<b>Title - Sujet :</b> Creek Crossing Rehabilitation – Grasslands National Park	
<b>Solicitation No. - N° de l'invitation :</b> 5P420-20-0444/A	<b>Date :</b> April 6, 2021
<b>Amendment No. - N° de modification :</b> 002	
<b>Client Reference No. - N° de référence du client :</b> N/A	
<b>GETS Reference No.   N° de référence de SEAG :</b> PW-21-00949467

## Amendment 002

This amendment is raised to extend the solicitation closing date, distribute the presentation materials from the bidders' conference on March 25, 2021, answer bidder questions and make revisions to the tender package.

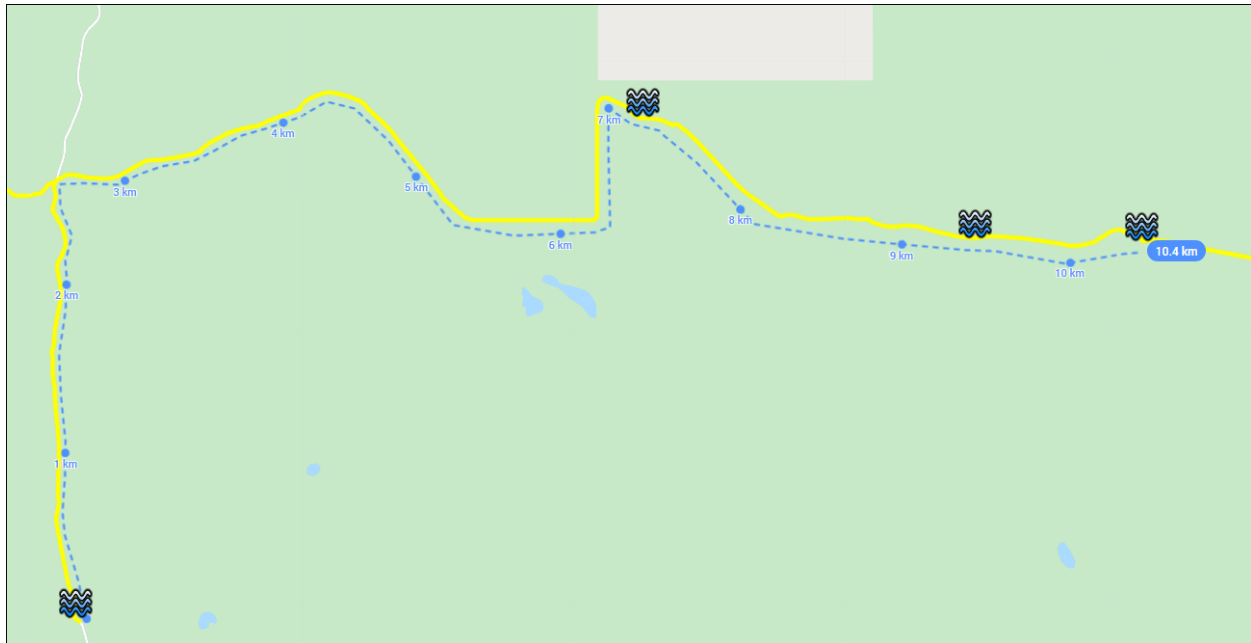
**Q3** How far apart are these 4 sites from each other?

**A3** Approximately **10 KM** from one end to the other.

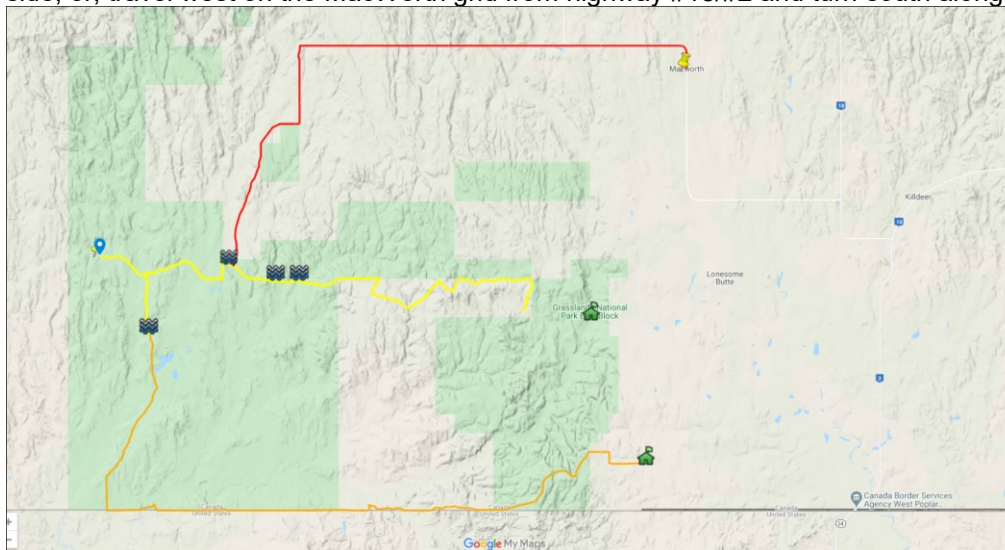
**Q4** What is the best way to access the sites?

**A4** <https://www.google.com/maps/d/edit?mid=17SofLHsJILOxbwNS5TWHEEE88fZ2W5Zt&usp=sharing>

For the closest access via pavement to the area, travel highway #18/#2 to the rural municipality (RM) gravel roads in the region. There are a couple options from this end; travel west on Monea road or West Poplar grid road from highway #18/#2 to Poverty Ridge Operations, entering the park from the far east side; or, travel west on the MacWorth grid from highway #18/#2 and turn south along an RM bladed trail.

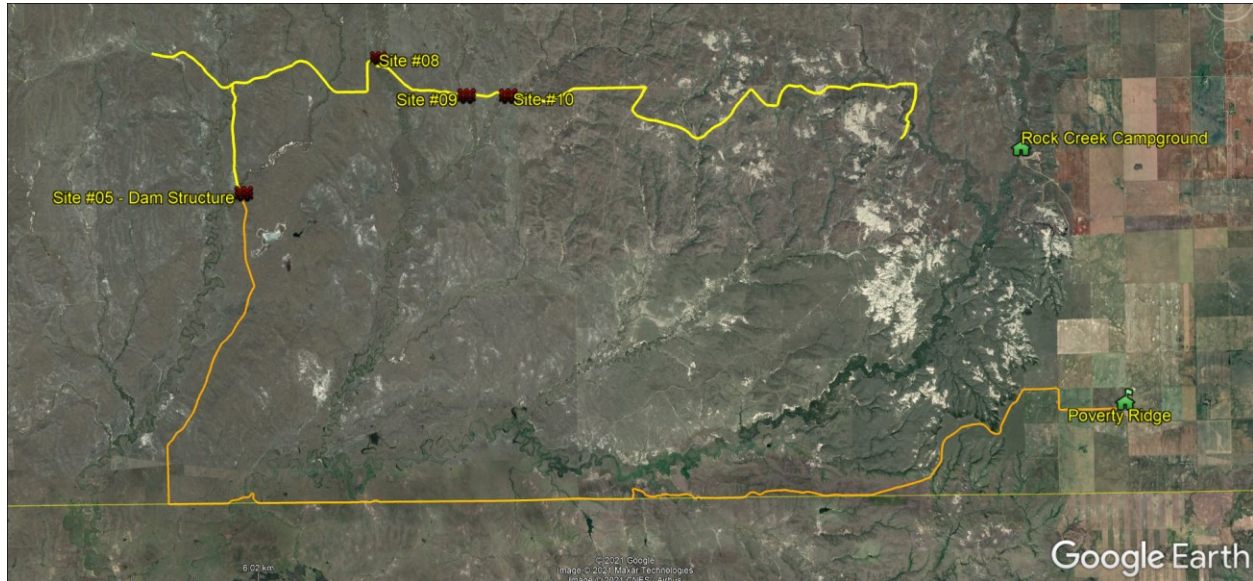
**Q5** How far away is Poverty Ridge from the sites?

**A5** Approximately **33 KM** from **Site #05**
